Access Compliance Report

Public Rights-of-Way

(Curb Ramps)

Intersection ID: 50616	Main Street: PADDLE_OAK_RD	Cross Street: FAWN_LILY	Location: SW
ADA ID: 6CF2DA160B36	Ramp Type: Perp	Initial Pass/Fail: Fail	Overall Compliance: No
Severity Score: 22.5			
Codes/Mitigation Info/Possible Solution		Field Measurements/Component Compliance

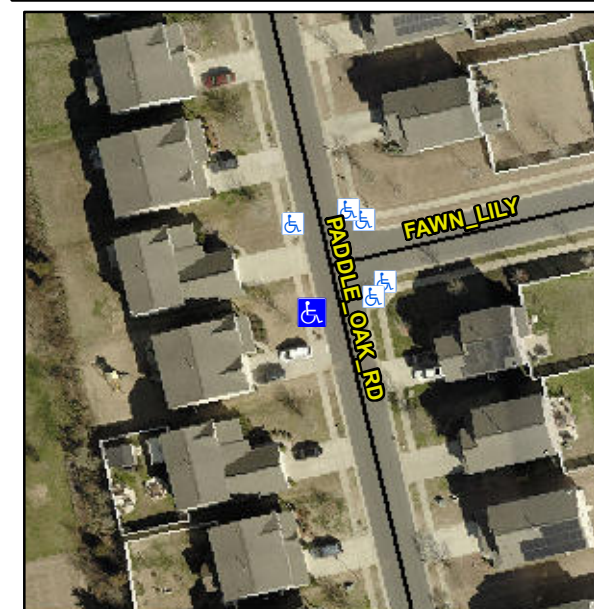
R304.5.1, R304.2.2

Compliance	Description	Data	Compliance	Description	Data
N/A	Ramp Length (in)	47.5	No	Ramp Slope (%)	9.4
No	Ramp Width (in)	47.0	Yes	Ramp XSlope (%)	2.9
N/A	Flare Type LT	N/A	N/A	Flare Type RT	N/A
N/A	Flare Slope LT (%)	N/A	N/A	Flare Slope RT (%)	N/A
N/A	Flare Traversable LT?	N/A	N/A	Flare Traversable RT?	N/A
N/A	Landing Length (in)	N/A	N/A	DWS Provided?	N/A
N/A	Landing Width (in)	N/A	N/A	DWS Contrast?	N/A
N/A	Landing Slope (%)	N/A	N/A	DWS Length (in)	N/A
N/A	Landing X Slope (%)	N/A	N/A	DWS Full Width?	N/A
N/A	Landing Curb? (Y/N)	N/A	N/A	DWS Offset (in)	N/A
N/A	Shared Landing?	N/A			
N/A	Gutter Ponding?	N/A	N/A	Gutter Slope (%)	N/A
N/A	Gutter Lip Ht (in)	N/A	N/A	Gutter X Slope (%)	N/A
N/A	Painted X Walk1?	No	N/A	Painted X Walk2?	N/A
	X Walk 1 Direction	To E		X Walk 2 Direction	N/A
N/A	X Walk 1 Width (in)	N/A	N/A	X Walk 2 Width (in)	N/A
	X Walk 1 Slope (%)	2.4		X Walk 2 Slope (%)	N/A
	X Walk 1 X Slope (%)	3.2		X Walk 2 X Slope (%)	N/A

Remove & Replace Entire Ramp.
